Florida Power & Light Company
St. Lucie Unit 1
Docket No. 50-335

Subject: Additional Responses to the NRC's Request for Additional Information

Attachment 1

Additional Responses to the NRC's RAIs Dated January 22, 2009 for FPL's

Figure 7-1: Containment Zone Locations

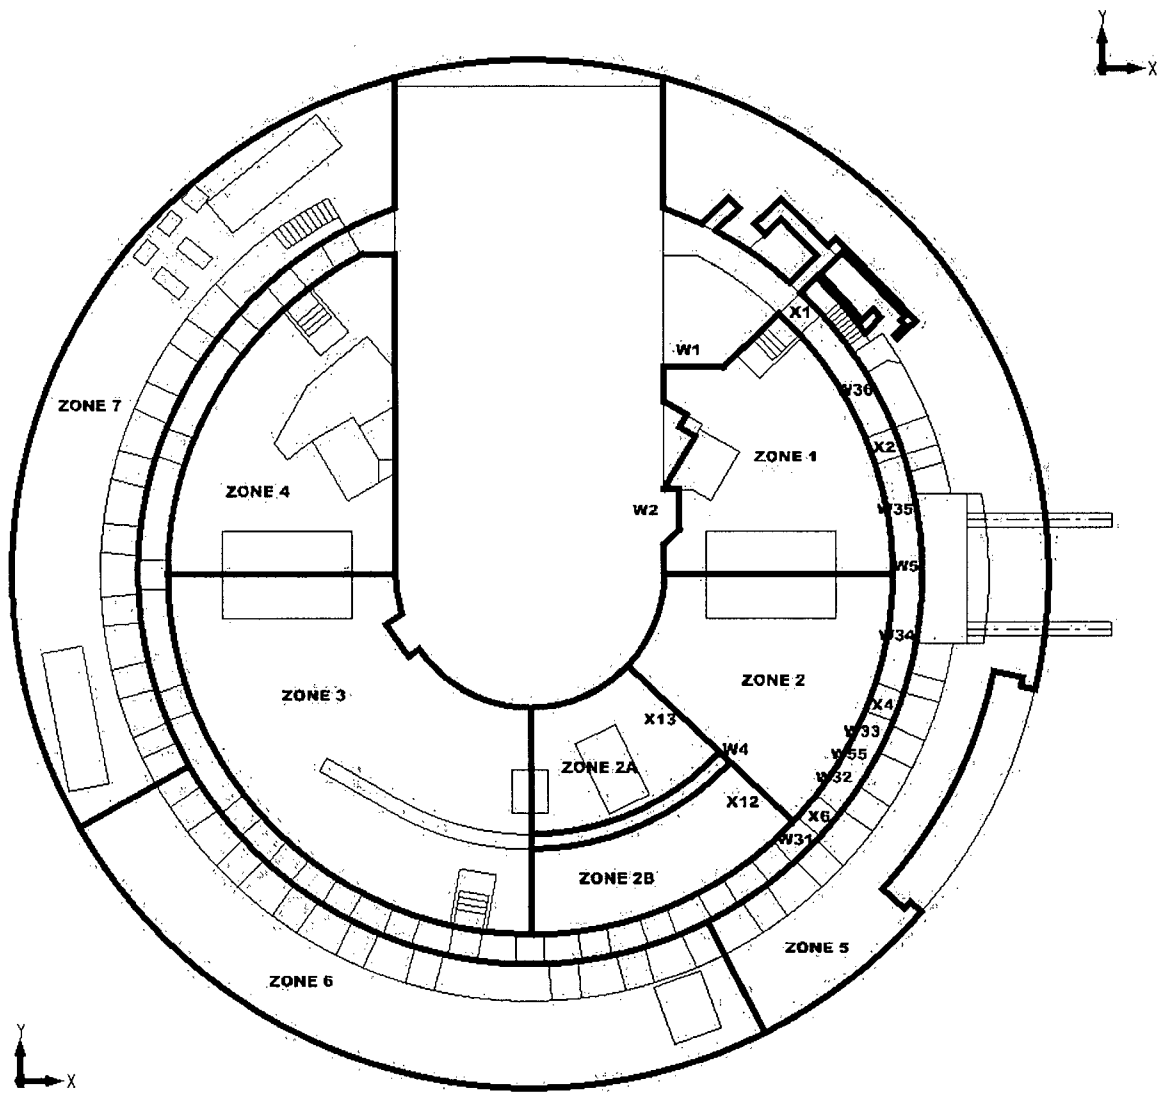
- a. It is unclear how blowdown, washdown, and pool-fill transport were analyzed.
- b. The supplemental response identifies only three distinct velocities in the entire containment pool: 0.113 ft/s inside the bioshield, 0.14 ft/s for 26.4% of the area outside the bioshield and 0.07 ft/s for the other 73.6% of the area outside the bioshield. The resolution (number of nodes in the licensee's calculation) does not appear sufficiently fine to provide a prototypical or conservative representation of actual flows in the containment pool.

- c. Based on the information provided, it is unclear how 20.6% of the sump pool was calculated to be a "turbulent zone" for large pieces and 30.6% was calculated to be a "turbulent zone" for small pieces. Furthermore, it is not clear that turbulence is the controlling parameter for the tumbling of small and large pieces of debris across the containment floor (e.g., versus velocity), or how a hand calculation can provide a reasonable estimate of the turbulence in the containment pool.

This discussion is a summary of the methodology applied to small debris. The lower containment was divided into seven (7) zones, as shown in Figure 7-1 below for illustration. Based on NEI 04-07 Volume 2, 25% of the small debris was transported vertically into upper containment and 75% remained in the lower containment. For conservatism it was assumed that all of the small debris that remained on the lower elevation was retained in zones 1 and 2 and subject to break flows during pool fill.

Initially large debris is assumed to be evenly spread over areas of zones 1 and 2. "S" values are the measured width of the opening. "L" values are the distance from the break to the center of the opening. Using the S/L ratio of the openings compared to the total S/L ratios, 13.04% of the large debris transports to the portal openings. The pool fill hydraulics will push the remaining large debris against the walls in zones 1 and 2, however 25% of the debris is assumed to shear off the wall (for conservatism) due to flow and transport along the walls to the drain portals. The debris that is transported to open portals (portals without strainers X1 and X2) will pass through and be deposited in the trench just beyond the portal opening. Debris that transports to portals with strainers (strainers installed in the drain portals X4 and X6) collect at the portal opening and will be available for further transport based on CFD analysis. Figure 7-1 shows the locations of these drain portals.

Figure 7-4: Isometric of St. Lucie Unit 1 ECCS Strainer System

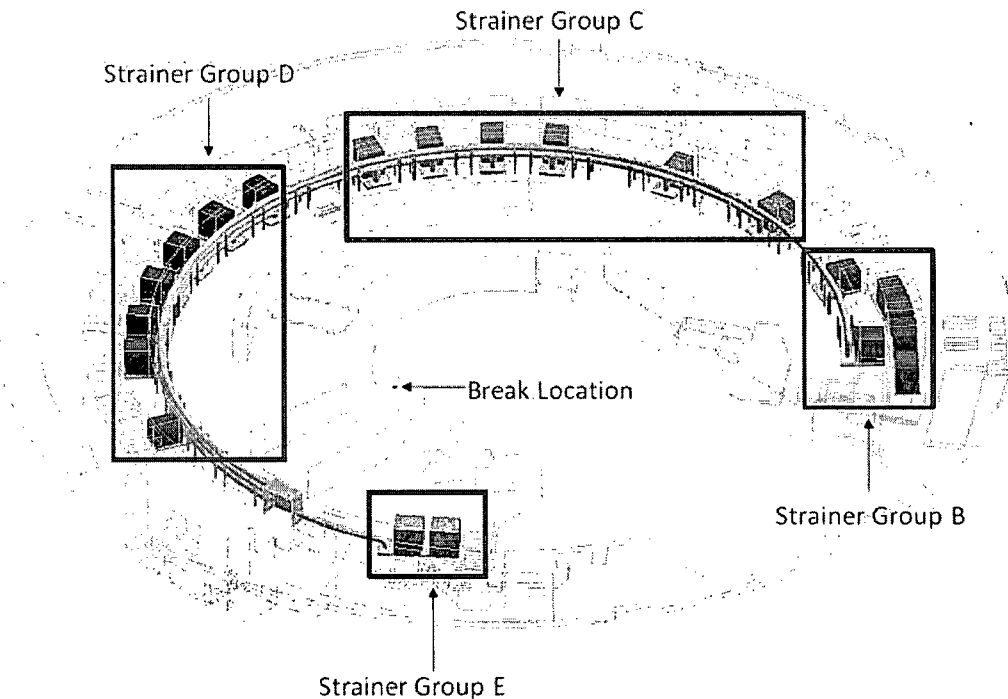
- d. It is unclear how the kinetic energy of the break flow and containment sprays was modeled. This flow splashing down into the containment pool can have a significant impact on the velocity and turbulence distributions in the containment pool. For St. Lucie Unit 1 the licensee assumed uniform containment spray drainage. However, the drainage from containment sprays frequently is not at the containment pool elevation due to non-uniformities in the structures at higher elevations that can result in concentrated drainage (e.g., refueling canal drains, hatch openings, gaps in curbs, etc.).

- e. The calculation appears to assume that all flow enters the physically nearest strainer module. This assumption is not likely to be valid for modules nearest the bioshield exits carrying the majority of the break flow (note that many licensees have seen significant tangential velocity components or swirling flow patterns near such modules). Neglecting tangential or swirling flow patterns leads to an under-prediction of the velocities throughout the containment pool and local to the strainer modules. Furthermore, without internal strainer flow control, it is not clear that modules nearest the sump suction pipes would not preferentially draw flow, particularly in light of the potential for the clean strainer head losses to result in non-uniform flow.

This section will discuss additional conservatisms with respect to pool fill and washdown. Figure 7-4 below shows the location of the ECCS strainers and the design basis break location. Note that the strainers are located on the 18 ft elevation.

In addition to the phenomenon described above, the scaling factor for determining the test strainer size, test flow rates, and test debris quantities included significant conservatisms which are related to the pool fill. Figure 7-4 shows that the break location is close to the E group of strainers. Due to the proximity to the break, it could be postulated that more debris would be washed into this strainer. For the purposes of scaling, both of the strainer modules were considered 100% blocked. Also, two additional strainer modules were considered 100% blocked. Because of conservative reductions the strainer area used for scaling was 6,527 ft² compared to the total strainer area of 8,187 ft². This represents yet another conservatism in the analysis.
